# Tech Tip

## Microbird “Horizontally Hinged” Emergency Window

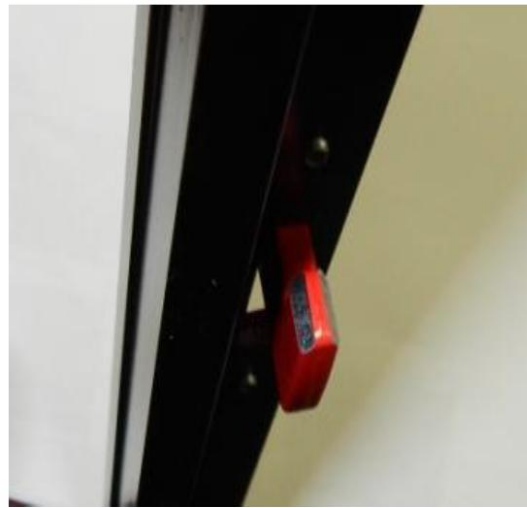
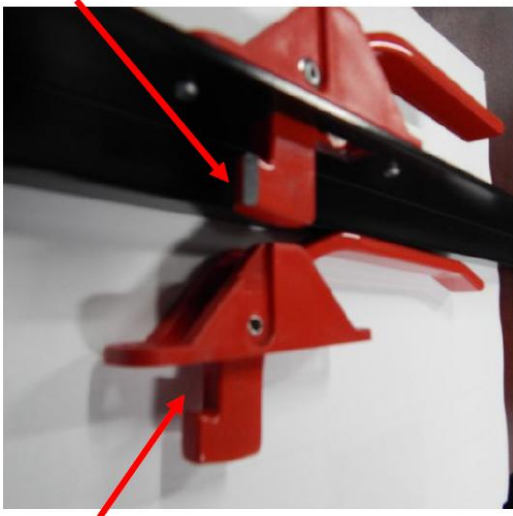
- Complaint –** We cannot get the window to “latch” without having someone apply pressure to the outside of the window while another person operates the latch.
- Cause –** The “nub” of the latch may be too “squared” off to grab the indent in the frame mount and “pull” the window shut.
- Correction –** Microbird has released the attached “modification” to address the issue.

If your bus is equipped with push out windows with a red handle on the bottom frame, and you cannot close the window shut from the inside without getting help from someone outside the bus, here is a quick fix the supplier has shared with us.

Simply grind both sides of the tab at a 45° angle, leaving the middle piece intact as per the following pictures.
